Access Compliance Report

Public Rights-of-Way

(Curb Ramps)

Intersection ID: 15217	Main Street: ALBEMARLE_RD	Cross Street: WINTERHAVEN_DR	Location: SW
ADA ID: A1E943BCE8BE	Ramp Type: Perp	Initial Pass/Fail: Fail	Overall Compliance: No
Severity Score: 8.75			
Codes/Mitigation Info/Possible Solution		Field Measurements/Component Compliance

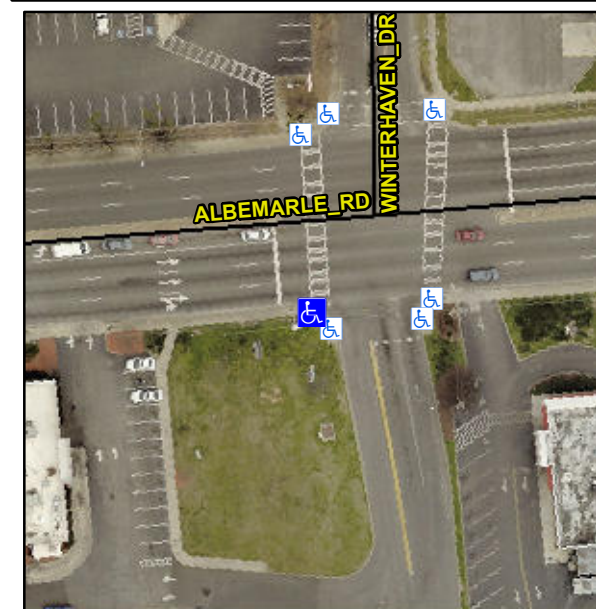
Not Found, R304.5.1

Compliance	Description	Data	Compliance	Description	Data
N/A	Ramp Length (in)	62.0	Yes	Ramp Slope (%)	6.0
No	Ramp Width (in)	40.0	Yes	Ramp XSlope (%)	0.3
N/A	Flare Type LT	N/A	N/A	Flare Type RT	N/A
N/A	Flare Slope LT (%)	N/A	N/A	Flare Slope RT (%)	N/A
N/A	Flare Traversable LT?	N/A	N/A	Flare Traversable RT?	N/A
N/A	Landing Length (in)	N/A	N/A	DWS Provided?	N/A
N/A	Landing Width (in)	N/A	N/A	DWS Contrast?	N/A
N/A	Landing Slope (%)	N/A	N/A	DWS Length (in)	N/A
N/A	Landing X Slope (%)	N/A	N/A	DWS Full Width?	N/A
N/A	Landing Curb? (Y/N)	N/A	N/A	DWS Offset (in)	N/A
N/A	Shared Landing?	N/A			
N/A	Gutter Ponding?	N/A	N/A	Gutter Slope (%)	N/A
N/A	Gutter Lip Ht (in)	N/A	N/A	Gutter X Slope (%)	N/A
N/A	Painted X Walk1?	Yes	N/A	Painted X Walk2?	N/A
	X Walk 1 Direction	To N		X Walk 2 Direction	N/A
N/A	X Walk 1 Width (in)	103.0	N/A	X Walk 2 Width (in)	N/A
	X Walk 1 Slope (%)	2.3		X Walk 2 Slope (%)	N/A
	X Walk 1 X Slope (%)	1.5		X Walk 2 X Slope (%)	N/A

Remove & Replace Entire Ramp.
